2020 STANDARD SPECIFICATION Updates

Road and Bridge Construction

The State of Delaware

JUNCTION BOX COVER SLAB DETAILS

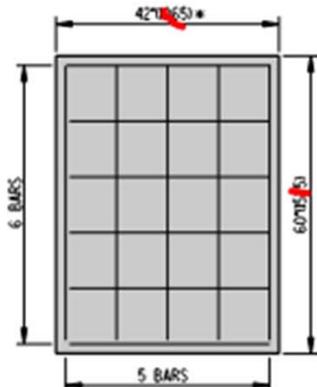
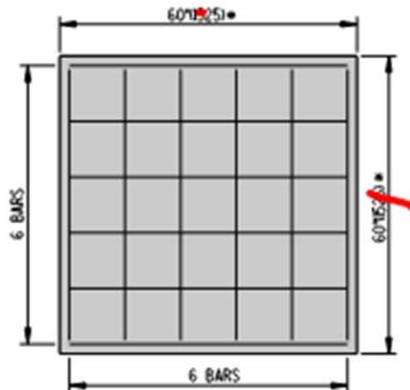
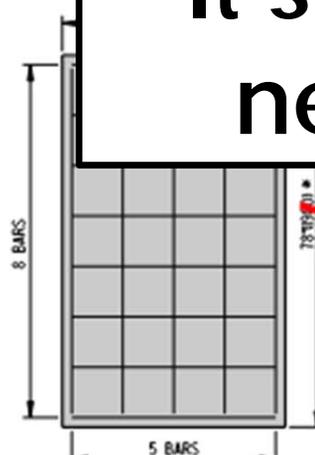
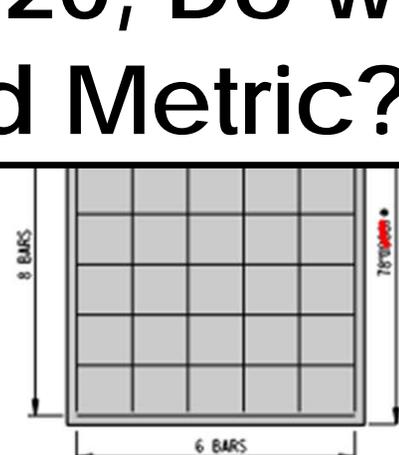
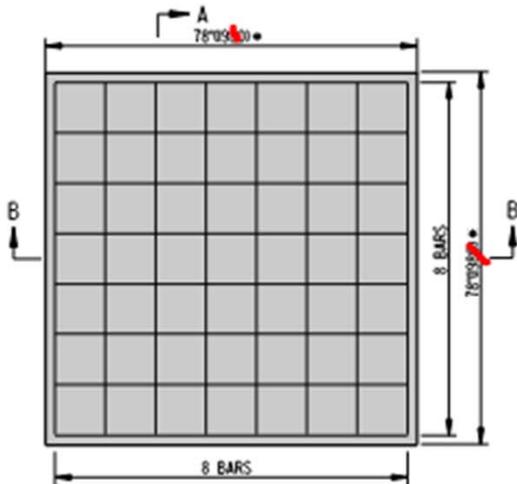
It's 2020, Do we need Metric?

remove metrics

INLET SEDIMENT CONTROL, DRAINAGE INLET

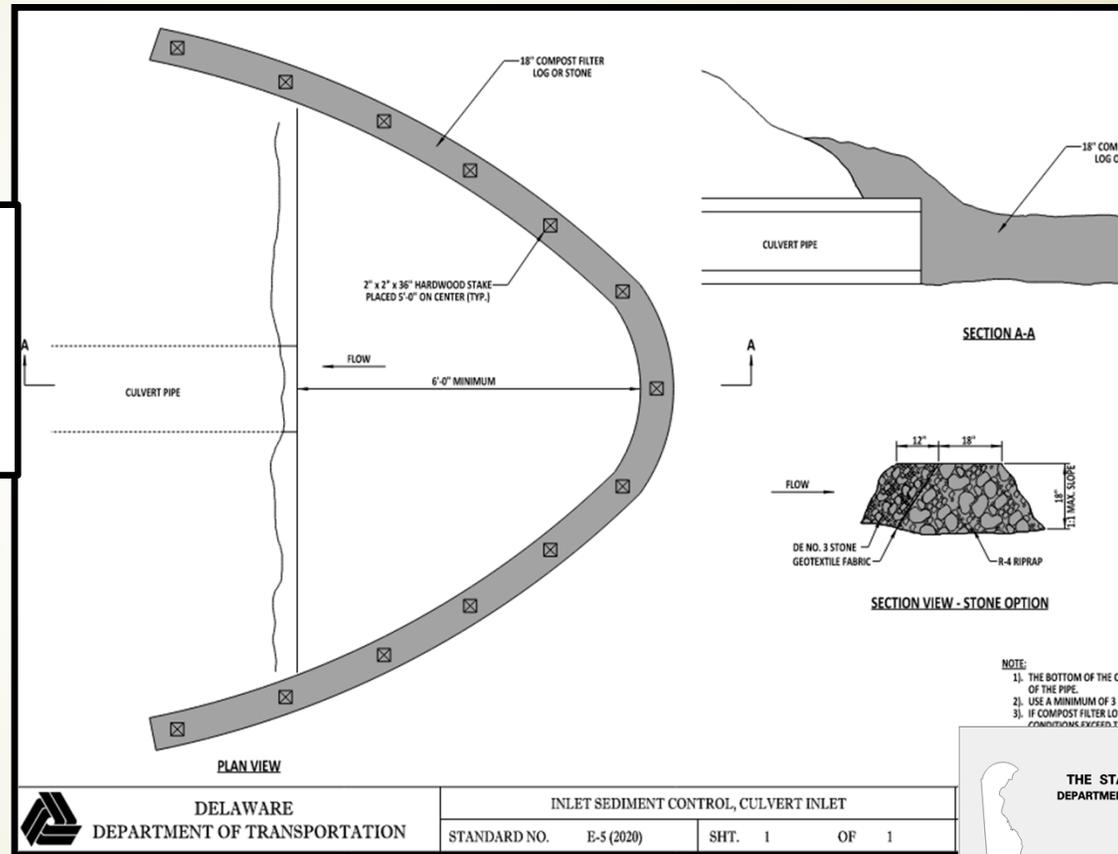
Use post and fence

INLET SEDIMENT CONTROL, CULVERT INLET
STANDARD NO. E-5 (2020) SHT. 1 OF 1

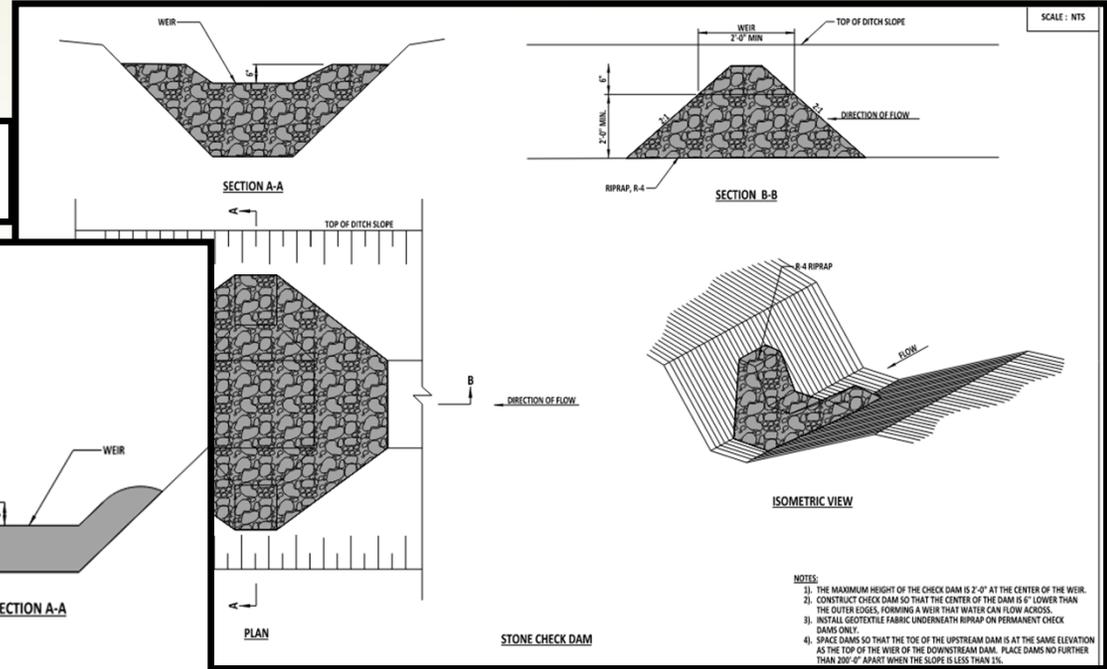
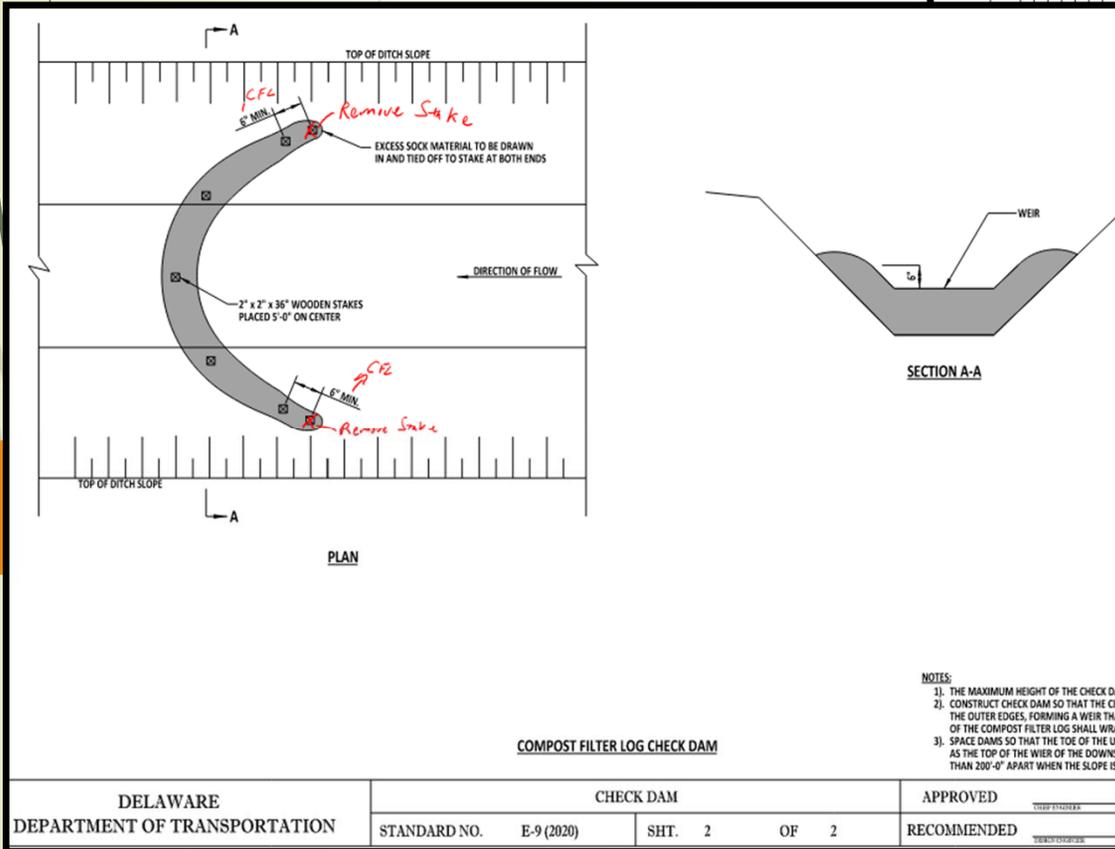
COMPOST FILTER LOG & STONE IS THE OPTION

TEMPORARY PEDESTRIAN PATHWAY
N.T.S.

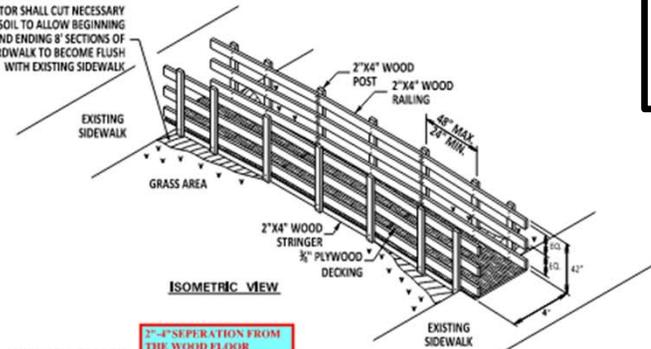
ADD NOTE: MAXIMUM ALLOWABLE RUNNING SLOPE NOT TO EXCEED 5%, MAXIMUM ALLOWABLE CROSS SLOPE NOT TO EXCEED 2% AND VERTICAL SURFACES NOT TO EXCEED 1/4\"/>

TEMPORARY SIDEWALK DETAIL - TYPE 2
N.T.S.

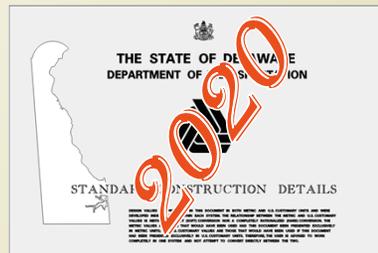
MAKE ITEMS PAYABLE BY THE DEPARTMENT

ADD NOTE: MAXIMUM ALLOWABLE RUNNING SLOPE NOT TO EXCEED 5%, MAXIMUM ALLOWABLE CROSS SLOPE NOT TO EXCEED 2% AND VERTICAL SURFACES NOT TO EXCEED 1/4\"/>
